Access Compliance Report Public Rights-of-Way (Curb Ramps)

Main Street: FRANKLIN_WAY Cross Street: BRYNWOOD_LN Location: SE

ADA ID: RPAT211104134717 Ramp Type: Type 4 - Parallel Initial Pass/Fail: Fail Overall Compliance: No Severity Score: 15

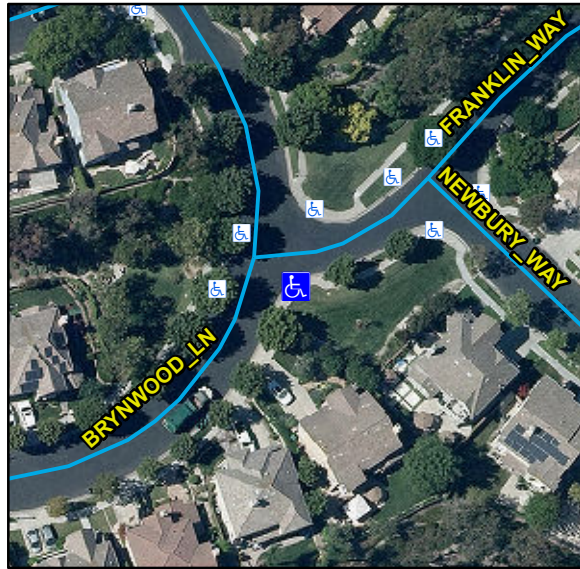
Compliance	Description	Data	Compliance	Description	Data
N/A	Ramp Length LT (in)	95	N/A	Ramp Length RT (in)	75
Yes	Ramp Width LT (in)	54	Yes	Ramp Width RT (in)	54
No	Ramp Run Slope LT (%)	9.1	Yes	Ramp Run Slope RT (%)	1.8
Yes	Ramp Cross Slope LT (%)	0.9	Yes	Ramp Cross Slope RT (%)	1.3
N/A	Landing Present	N/A	N/A	DWS Provided	N/A
N/A	Landing Length (in)	N/A	N/A	DWS Contrast	N/A
N/A	Landing Width (in)	N/A	N/A	DWS Length (in)	N/A
N/A	Landing Run Slope (%)	N/A	N/A	DWS Full Width	N/A
N/A	Landing Cross Slope (%)	N/A		DWS Offset Type	N/A
N/A	Landing Movement Obstructed?	N/A	N/A	DWS Offset Left (in)	N/A
	Landing Movement Type	N/A	N/A	DWS Offset Right (in)	N/A
N/A	Landing Shared	N/A			
N/A	Clear Space	Yes			
N/A	Clear Space To Crosswalk (in)	N/A			
N/A	Marked Crosswalk 1	No	N/A	Marked Crosswalk 2	No
	Crossing 1 Direction	N		Crossing 2 Direction	W
	Marked Crosswalk 1 Width (in)	N/A		Marked Crosswalk 2 Width (in)	N/A

Remove & Replace Curb Ramp With Two New Directional Ramps or Equivalent.

R304.3.2, STD 1115
